Model: Model G-P1	Date: 24-Feb-05	No.: RG104001a
-------------------	-----------------	----------------

Subject: Engine firmware release note for G-P1		Prepared by: K. Moriizumi	
From: 1st Tech. Support Sec. Service Support Dept.			
Classification:	<input type="checkbox"/> Troubleshooting	<input type="checkbox"/> Part information	<input type="checkbox"/> Action required
	<input type="checkbox"/> Mechanical	<input type="checkbox"/> Electrical	<input type="checkbox"/> Service manual revision
	<input type="checkbox"/> Paper path	<input type="checkbox"/> Transmit/receive	<input type="checkbox"/> Retrofit information
	<input checked="" type="checkbox"/> Other ()

Model: Model G-P1		Date: 29-Jun-05	No.: RG104005
Subject: Envelope wrinkles		Prepared by: K. Moriizumi	
From: 1st Tech. Support Sec. Service Support Dept.			
Classification:	<input checked="" type="checkbox"/> Troubleshooting	<input type="checkbox"/> Part information	<input type="checkbox"/> Action required
	<input type="checkbox"/> Mechanical	<input type="checkbox"/> Electrical	<input type="checkbox"/> Service manual revision
	<input type="checkbox"/> Paper path	<input type="checkbox"/> Transmit/receive	<input type="checkbox"

<< Fig. 1 >>

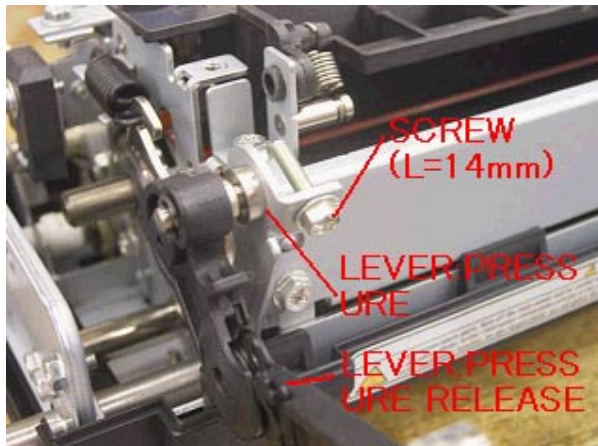
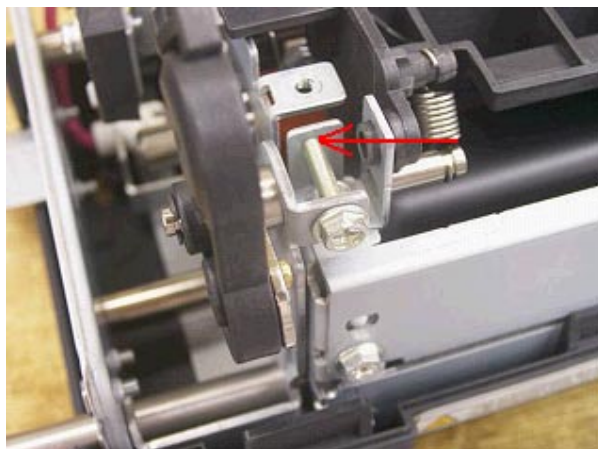
Countermeasure for envelope wrinkles

2-1. Fusing pressure adjustment procedure

- 1) Remove the upper cover of the fusing unit. (4 screws)
- 2) Install the screws in the screw holes of the fusing pressure lever in both sides of the fusing unit as shown in Fig.1. (M3 x 14mm screws are best for this adjustment.)
- 3) Please confirm that the pressure release levers move smoothly and the edge of the screw touches the frame when fusing pressure is applied as shown in Fig.2.
- 4). Reinstall the upper cover.

The following screws are suitable for this adjustment.

03530140N: SCREW:M3X14

04512014N: TAPPING SCREW:3X14

03603014N: SCREW:M3X14

To correct the fusing ability after reducing the fusing pressure, the following SP setting changes are required.
